Service Bulletin Fuel Systems

Bulletin No.: MSA-3
Revision No.: 1
Date: 11/16/90
Revised: 11/18/91

SUBJECT: OVERHAUL PERIODS FOR FLOAT CARBURETORS.

SUBJECT: BOWL CLEARANCE MA- SERIES CARBURETORS

Fig. 1

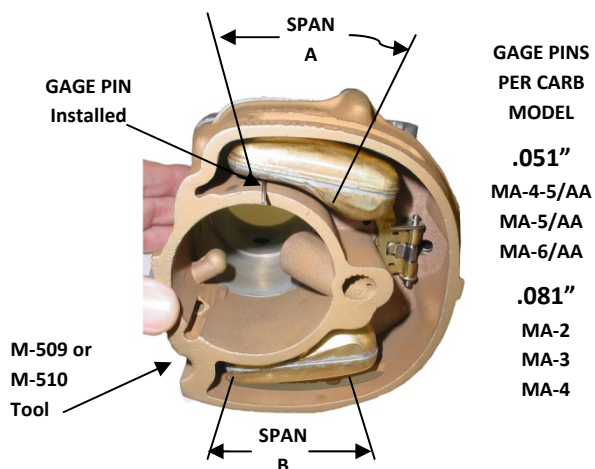
1. **Reasons:** **Warning:** **Failure to follow this advice may result in engine malfunction, damage, injury or death.** Reports of sticking, leaking and/or worn floats have been received, see Figure 1. The specified float/bowl clearance **MUST** exist to ensure proper operation.

Fig. 2

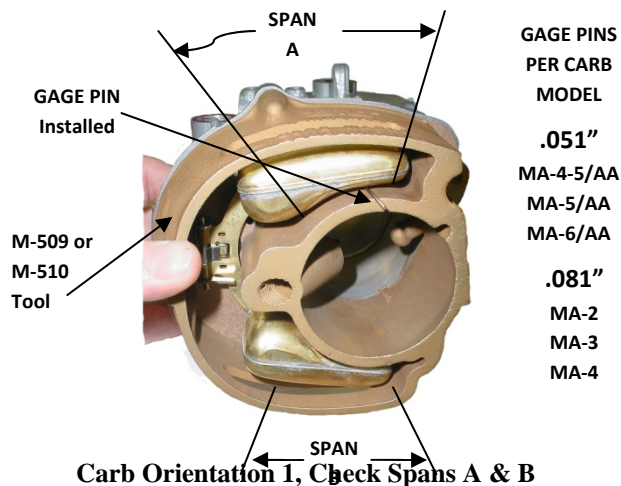
With the clearance tool M-510 used with the (MA-3, MA-4 series) or M-509 used with the (MA-5, MA-6, MA-4-5 Series) in place, orient the carburetor body with one pontoon uppermost, see Figure 2. Check the clearance between the float pontoon and the bowl wall. A .081 inch gage pin (models MA-2, MA-3 & MA-4), or a .051 gage pin (models MA-4-5, MA-4-5AA, MA-5, MA-5AA, MA-6 and MA-6AA) must pass between the lower surface of the upper pontoon and the throttle bore wall and between the lower surface of the lower pontoon and the lower bowl wall without touching either pontoon. Reorient the carburetor so that the other pontoon is uppermost, see Figure 3. Repeat the clearance check. If, as the gage pin is moved along between the float and the bowl wall the gage pin contacts either pontoon, float clearance is inadequate and the float assembly must be replaced.

Fig. 6

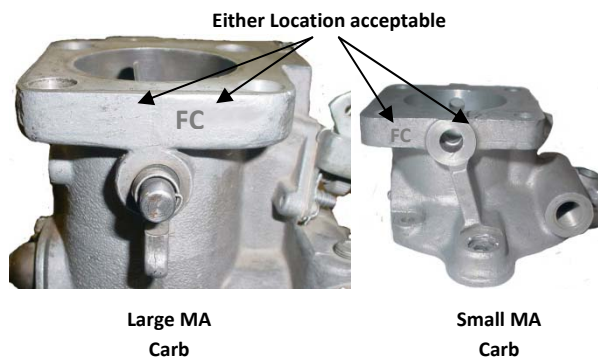
5. **Identification/Marking:** Upon completion of this Flight Safety Service Bulletin, stamp the letters "FC" ($\frac{1}{8}$ inch tall (nominal) characters) on the flange adjacent to the throttle shaft, see Figure 6.
